April 7, 2016

Re: MRC/Fiberight Solid Waste Processing Facility Site Plan Review

Re: Preliminary MRC/Fiberight Solid Waste Processing Facility Site Plan Review

RE: Preliminary Traffic Review for Hampden Solid Waste Processing Facility

# Hampden Solid Waste Processing Facility

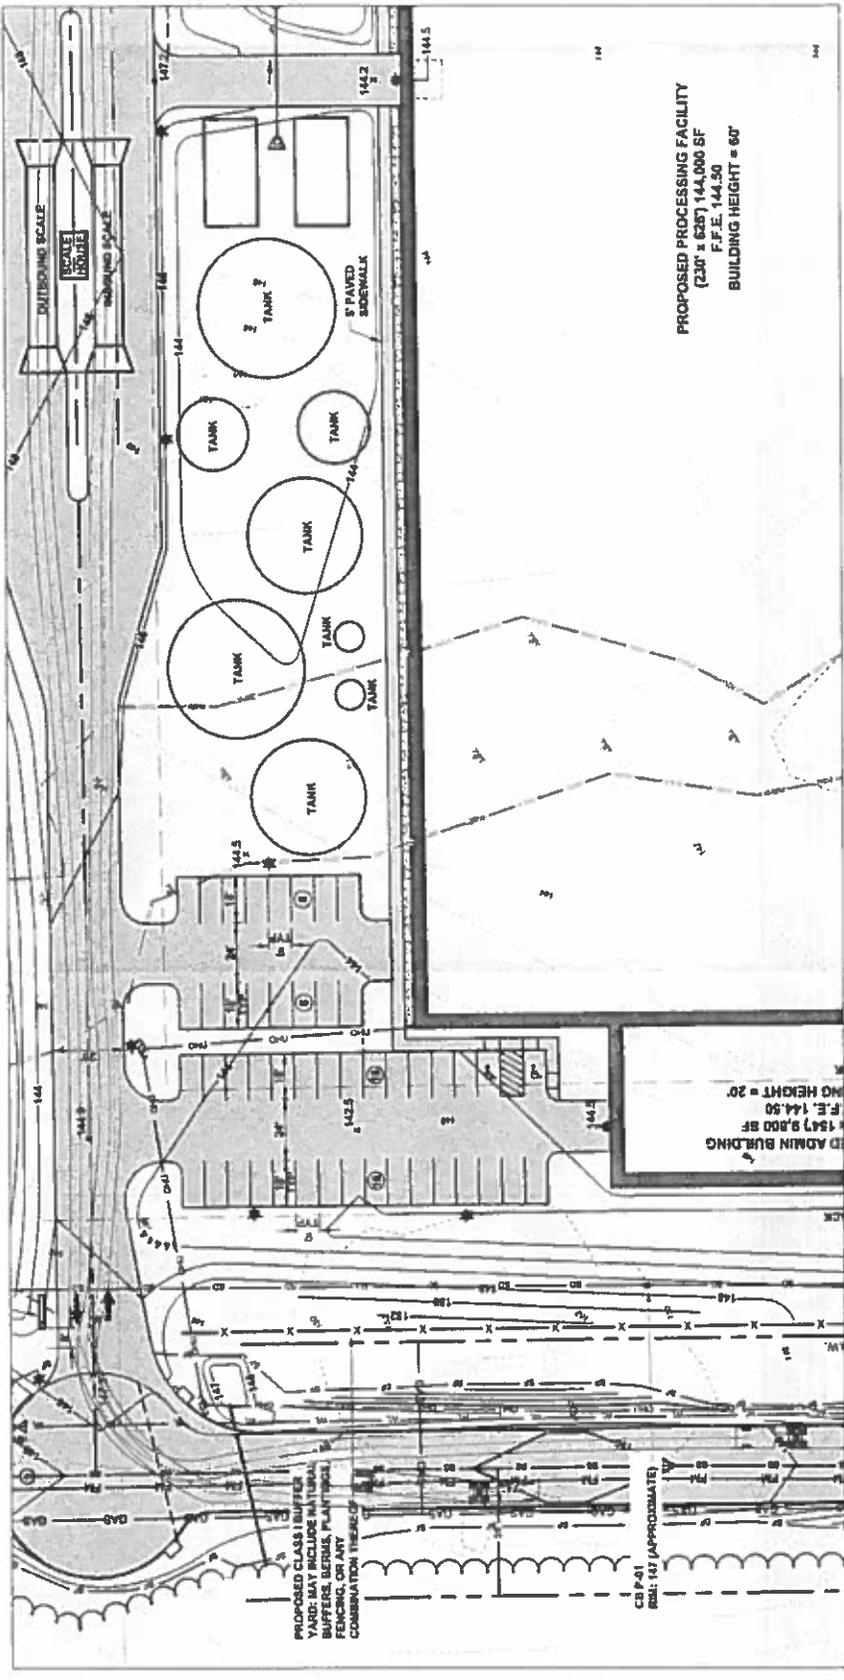
AutoTurn runs performed by Maine Traffic Resources show that a WB-67 tractor trailer truck will need to use all of the access road to make the turn in and out of the facility in the area of the cul-de-sac making it unsafe for other vehicles, particularly for automobiles entering or exiting the parking lots. The access road needs to be widened in this area to assure that trucks do not need to cross centerline to access the facility. AutoTurn runs showed no issues at the Coldbrook Road intersection. The AutoTurn runs are attached for your information.
